YMP YUCCA MOUNTAIN PROJECT	**Model** **Error Resolution Document** *Complete only applicable items.*	QA: QA Page 1 of 2

1. Document Number:	MDL-WIS-PA-000005	**2. Revision/Addendum:**	Rev 00 and AD 01	**3. ERD:**	ERD 05
4. Title:	Total System Performance Assessment Model/Analysis for the License Application				
5. No. of Pages Attached:	24

An impact analysis was performed for TSPA-LA Rev00 [DIRS 178871] and the addendum [DIRS 183478]. For Rev00, a total of 12 controlled documents were found, however, none of the documents are using the TSPA-LA as a direct input, nor do they reference any of the sections being revised in this ERD. For the Addendum, 8 controlled documents were found, of these, two use the Addendum as a direct input but are affected only by changes in this ERD related to CR 12543 (ANL-WIS-MD-0000027 Rev 00 and ANL-DS0-NU-000001 Rev 00). It should also be noted that CAL-DN0-NU-000002 Rev 00C uses the localized corrosion DTN (CR 12543) as direct input, and will also be affected. The SAR has been evaluated for changes needed due to this ERD and will require minor modifications through the LCR process. These changes will have no effect on the results and conclusions pre

Figure O-1. Fraction of Locations with the Potential for Localized Corrosion Initiation as a Function of Drip Shield Failure Time: (a) Bin1, CDSP; (b) Bin1, CSNF; (c) Bin2, CDSP; (d) Bin2, CSNF; (e) Bin3, CDSP; (f) Bin3, CSNF; (g) Bin4, CDSP; (h) Bin4, CSNF; (i) Bin5, CDSP; and (j) Bin5, CSNF

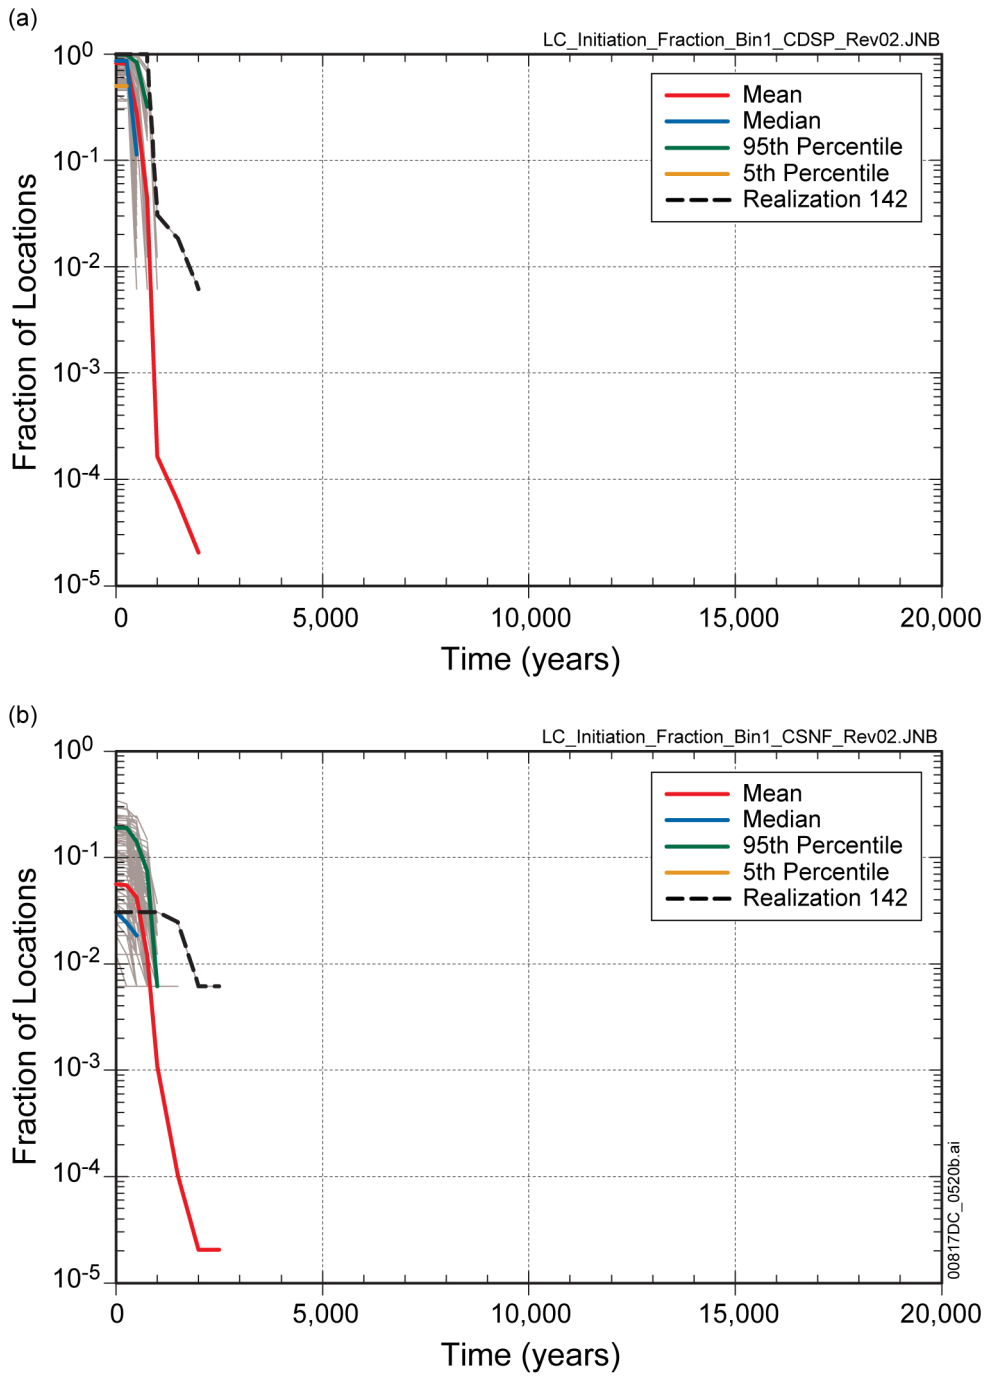
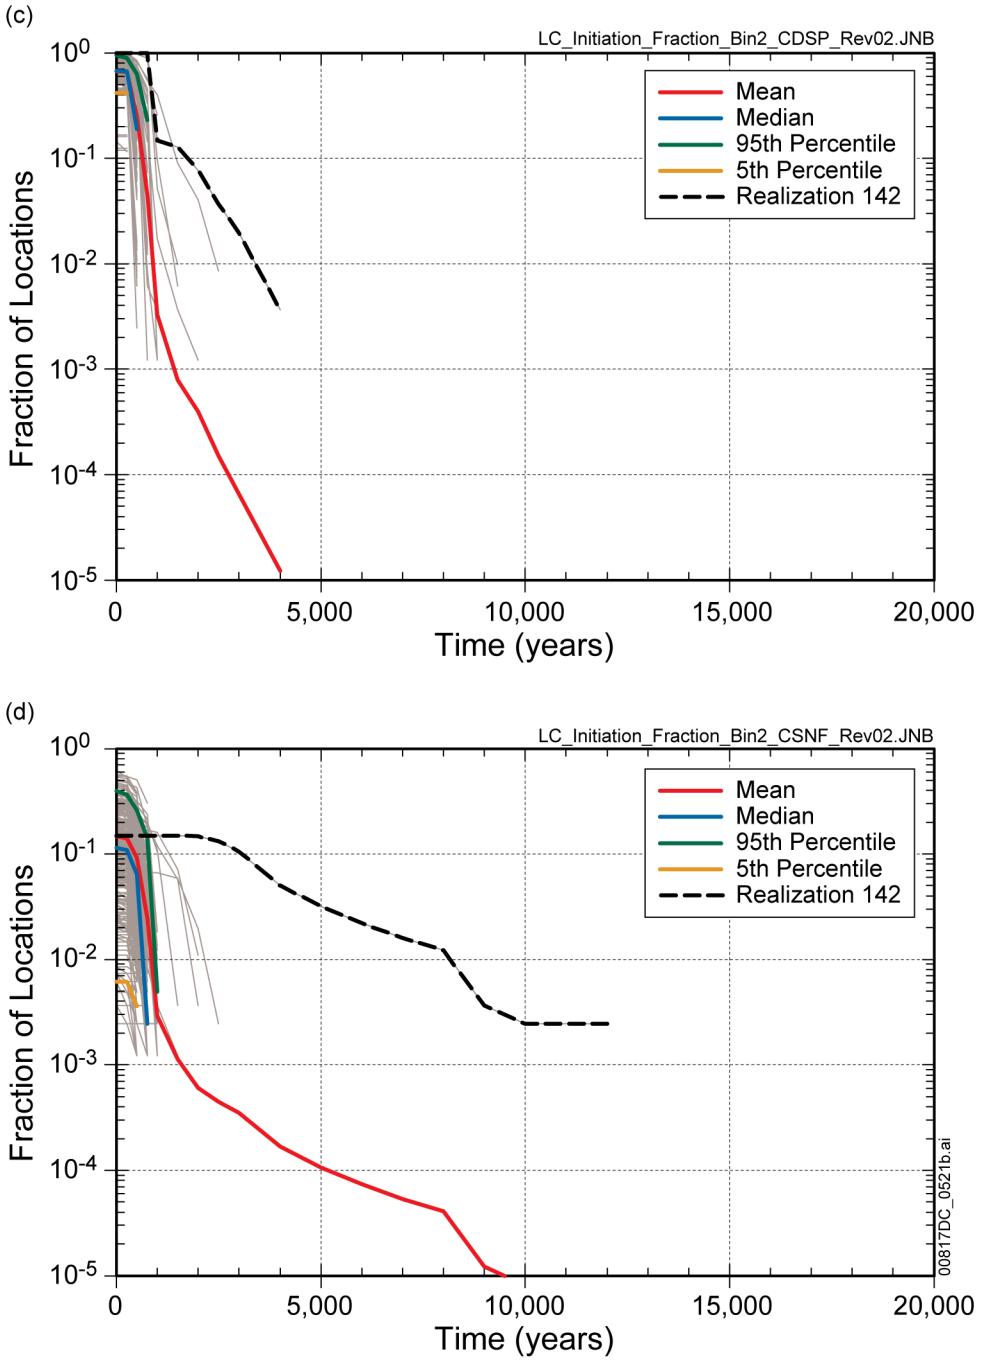
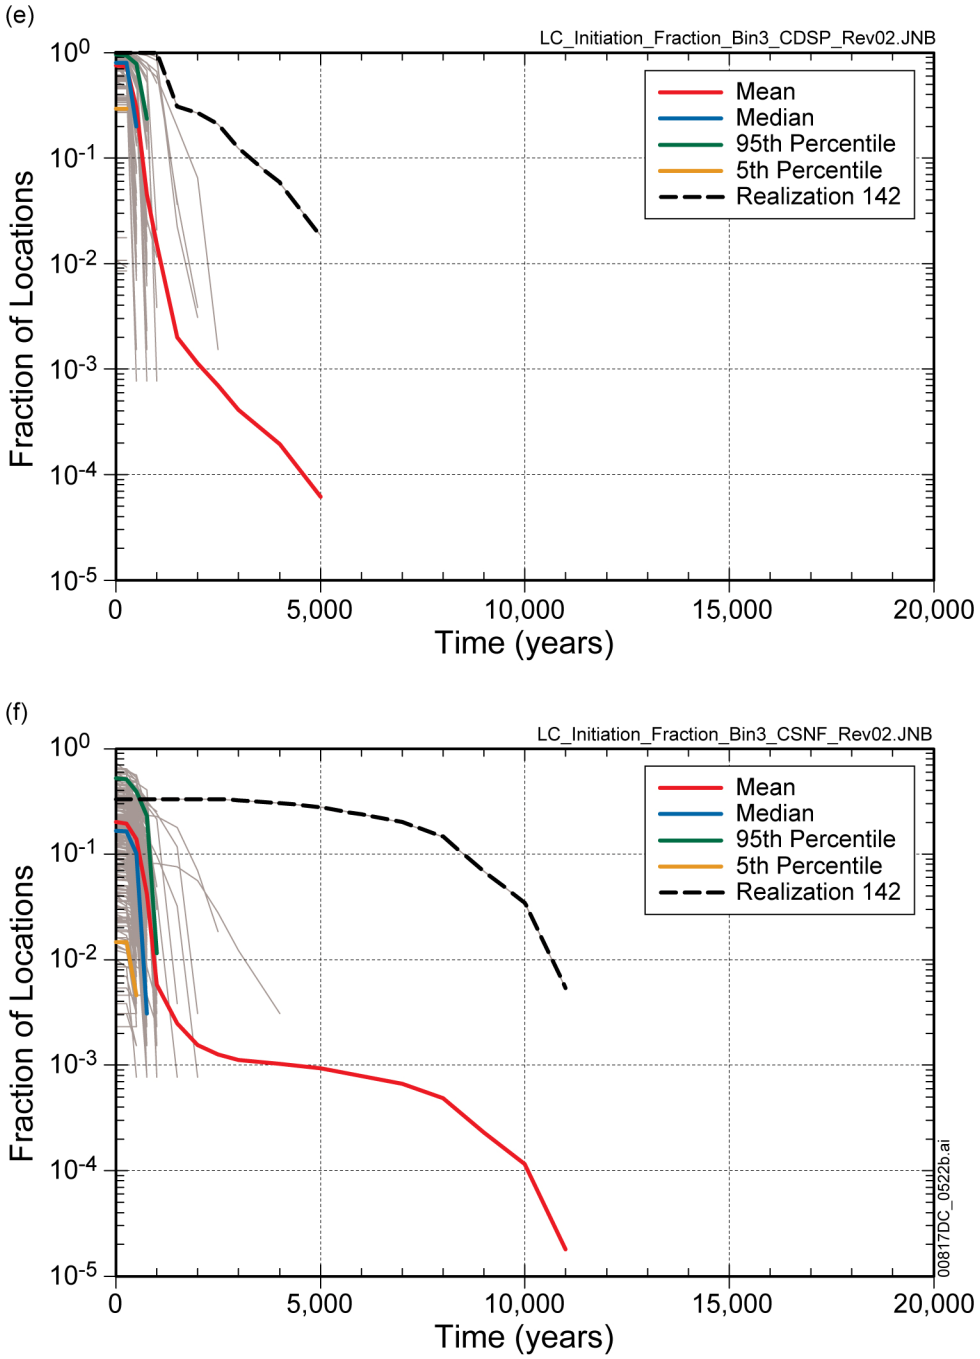
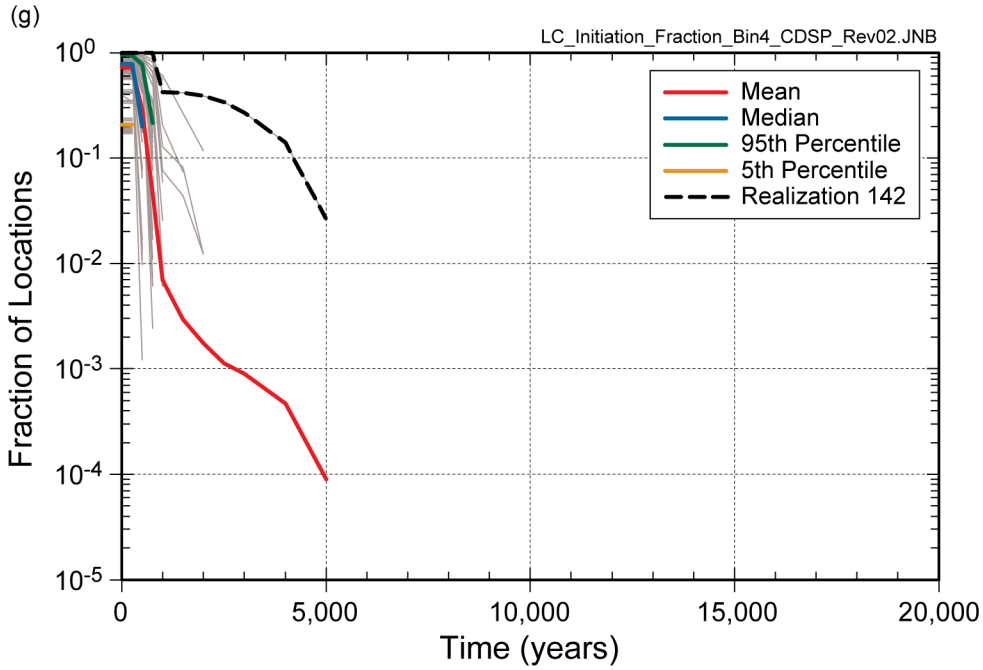
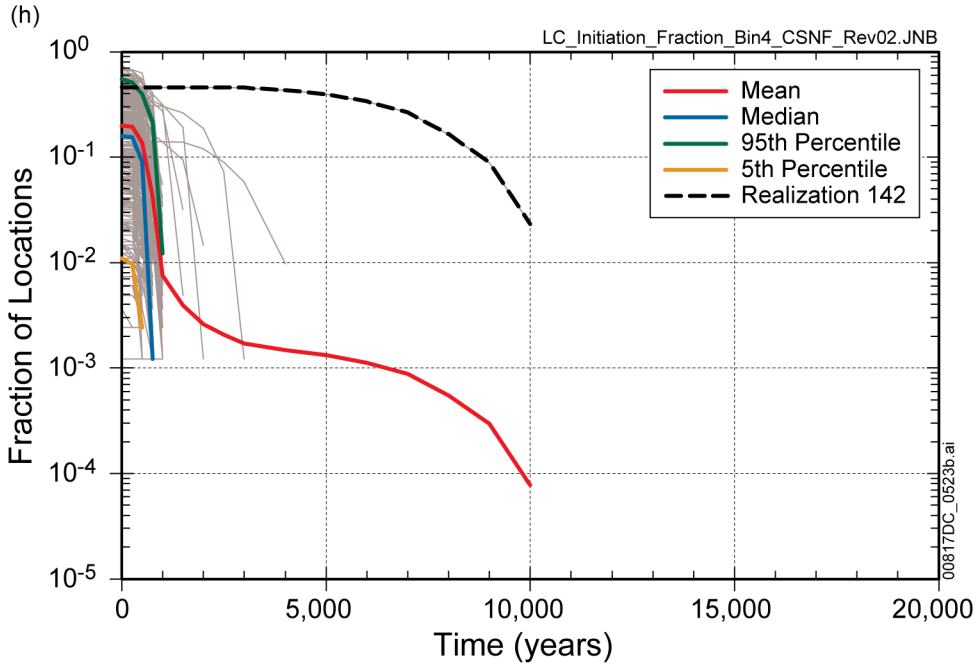
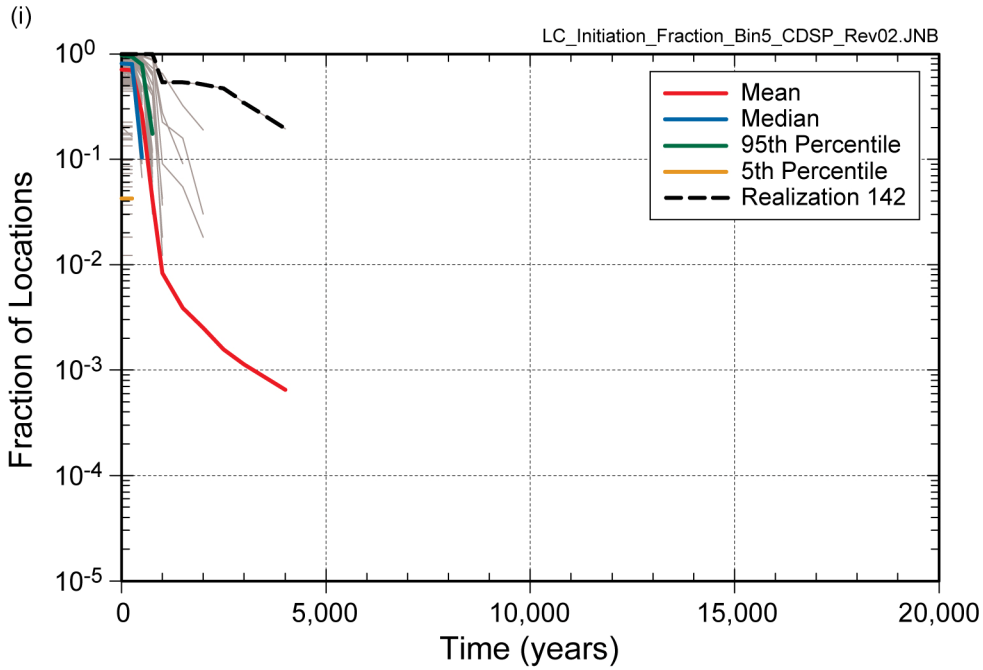
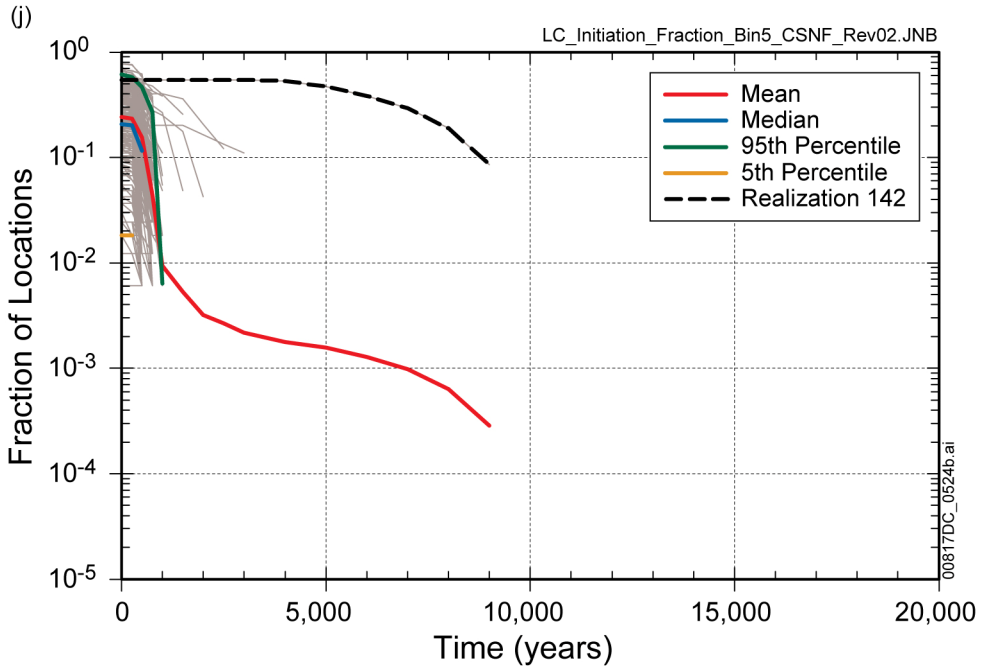
CR 12543—Salt separation error in localized corrosion initiation analysis.

In TSPA-LA Rev00, Section 6.3.5.2 describes the model abstraction for initiation of localized corrosion on the WP outer barrier. As part of this abstraction, localized corrosion is assumed to initiate if salt-brine separation occurs during re-wetting of the WP outer barrier. TSPA implements the abstraction for initiation of localized corrosion in a set of GoldSim model files documented in output DTN: MO0709TSPALOCO.000_R0 [DIRS 182994]). However, it has been determined that localized corrosion from the occurrence of salt separation was not accounted for in these model files due to an incomplete implementation. The analysis with these model files is documented in the TSPA-LA Appendix O.

A new analysis has been completed with the appropriate implementation of localized corrosion being initiated from the occurrence of salt separation and the output DTN updated (MO0709TSPALOCO.000 [DIRS 185808]). This ERD updates the discussion presented in Appendix O of the parent document (Attachment 1), which is based on TSPA-LA Model v5.000 (output DTN: MO0709TSPAREGS.000 [DIRS 182976]) with results from the new analysis and dose histories from TSPA-LA v5.005 (output DTN: MO0710ADTSPAWO.000 [DIRS 183752]). The original dose analysis evaluating the impact of localized corrosion in the Seismic Ground Motion Modeling Case for 10,000 years (DTN: MO0708FREQCALC.000 [DIRS 183006]) presented in Section 7.3.2 of the parent document has also been updated (Attachment 2) with the corrected localized corrosion model results and TSPA-LA v5.005 dose histories from output DTN: MO0710ADTSPAWO.000 [DIRS 183752]. Attachment 2 contains a replacement for TSPA-LA Figure 7.3.2-17; however no modification to the text was required. Attachment 3 contains areas in the document which should be revised to reflect the new localized corrosion DTN.

ATTACHMENT 1—REPLACE APPENDIX O (CR 12543)

This appendix presents the Localized Corrosion Initiation Uncertainty Analysis, which implements the Localized Corrosion Initiation Submodel described in Section 6.3.5.2. The original Localized Corrosion Initiation Model is developed in *General Corrosion and Localized Corrosion of Waste Package Outer Barrier* (SNL 2007 [DIRS 178519], Sections 6.4.4, 6.4.4.3.1, and 6.4.4.5). The main result of this analysis is the fraction of locations in the repository that have the potential for localized corrosion initiation if the drip shield fails at a given time. This fraction is the cumulative fraction of WP locations that can potentially corrode any time after the drip shield fails. The analysis also provides support for the tables of zeros for localized corrosion in the TSPA-LA Model. The results of the Localized Corrosion Initiation Uncertainty Analysis are also used to support screening arguments that localized corrosion initiation can occur only with a low probability and only at a few locations in the repository.

Figure O-2. Fraction of Locations in Each Percolation Subregion with the Potential for Localized Corrosion Initiation after the Drip Shield Fails as a Function of Drip Shield Failure Time

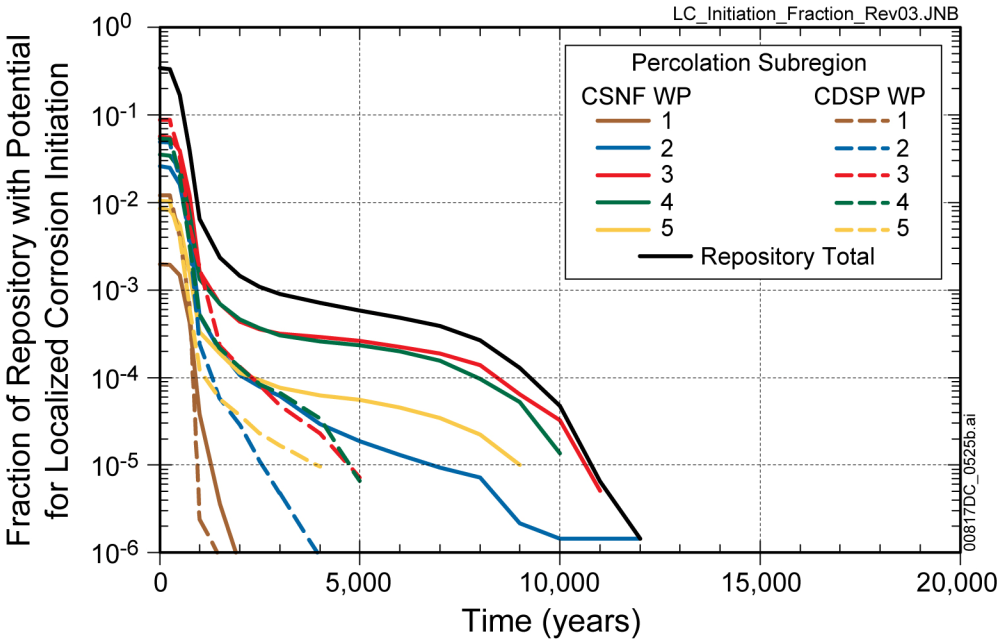
Figure O-2 shows the average fraction of all WPs that could potentially experience localized corrosion, computed by multiplying each of the mean curves on Figure O-1 by its respective bin fraction (0.05, 0.25, 0.40, 0.25, and 0.05) and its WP type fraction (3416/11629 for CDSP WP and 8213/11629 for CSNF WP). There are more CSNF WPs and they are hotter so CSNF WPs comprise a larger fraction of the total number of WPs that could experience localized corrosion. The repository total curve shows the mean fraction of WPs with potential for localized corrosion for the entire repository. The average fraction of WPs on which localized corrosion may potentially initiate peaks at about 0.34 for the first few hundred years after closure when the repository is hot, and highly concentrated solutions exist on the WP surface. Of the 0.34 fraction, about 0.1 is from the corrosion potential only and the remainder is from the chloride rich brine resulting from salt separation (or both). After a few thousand years, the fraction of WPs with the potential for localized corrosion initiation decreases to below 10^{-3}.

In the table of contents, update the figure caption of Figures O-1 and O-2.

Figure O-3. Average Delta E for Percolation Subregion 3, CSNF, for 300 Epistemic Realizations

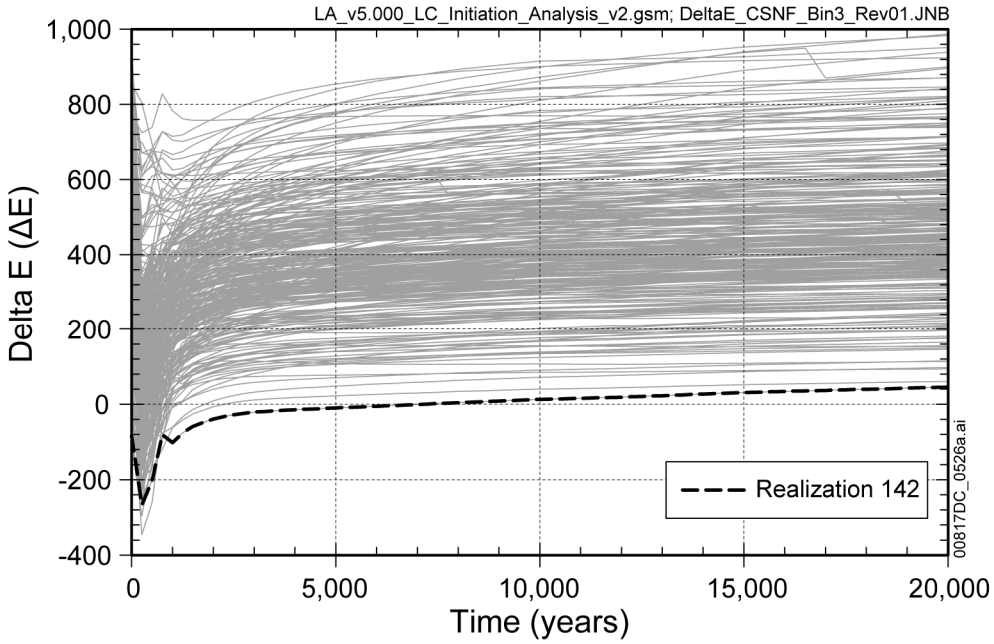
The time histories of the chemical conditions and ΔE at every node for every realization cannot reasonably be shown. However, the time histories of the mean of all the nodes in a single bin can be shown. The values for the CSNF WPs in bin 3 are shown to represent the range of values for ΔE, with Realization 142 highlighted. Figure O-3 shows the value of ΔE, averaged over all of the 1,300 nodes for this bin. Notice that the mean ΔE for realization 142 is the last to go above zero. As mentioned previously, the large negative value for the parameters shown in Equation O-3 keeps ΔE low. The highest curves on Figure O-3, which have large positive values for the parameters in Equation 3, are never close to zero. Thus, localized corrosion due to ΔE never occurs in these realizations.

Figure 7.3.2-17. Expected Annual Dose Over 10,000 Years from Seismic Ground Motion Events that Result in Drip Shield Plate Failure

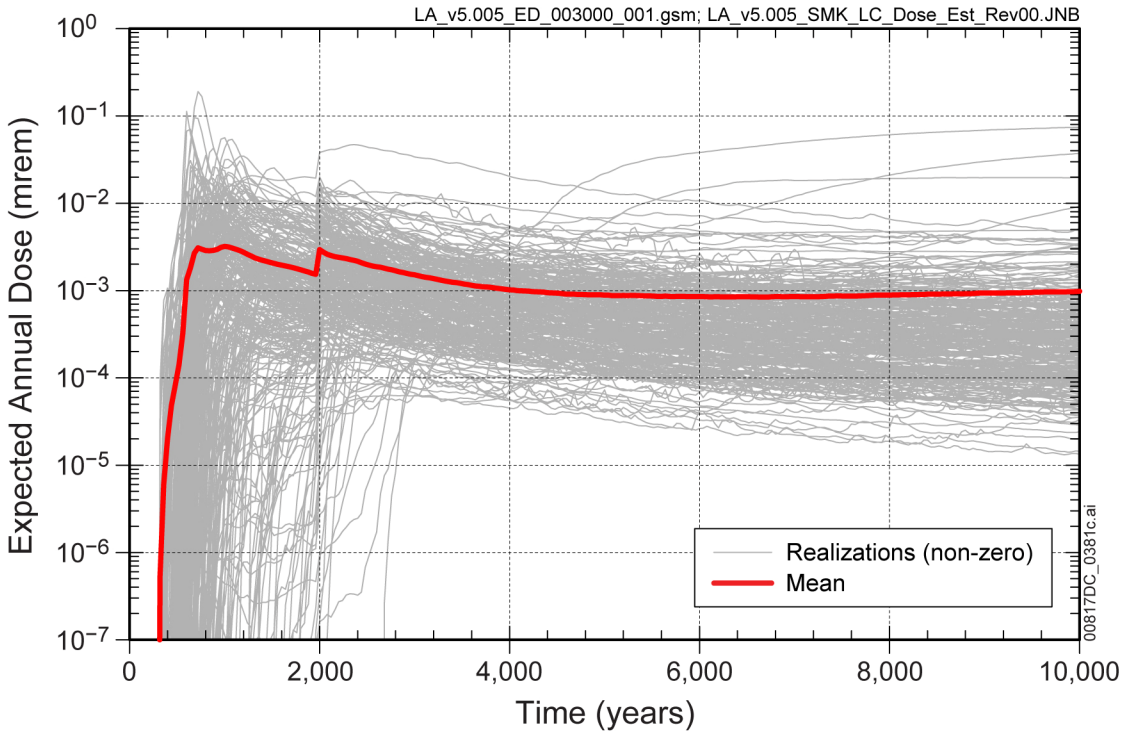
ATTACHMENT 2—REPLACE FIGURE 7.3.2-17 ON PAGE F7.3.2-17

NOTE: This figure has been updated to use dose data from v5.005 of the TSPA-LA Model.
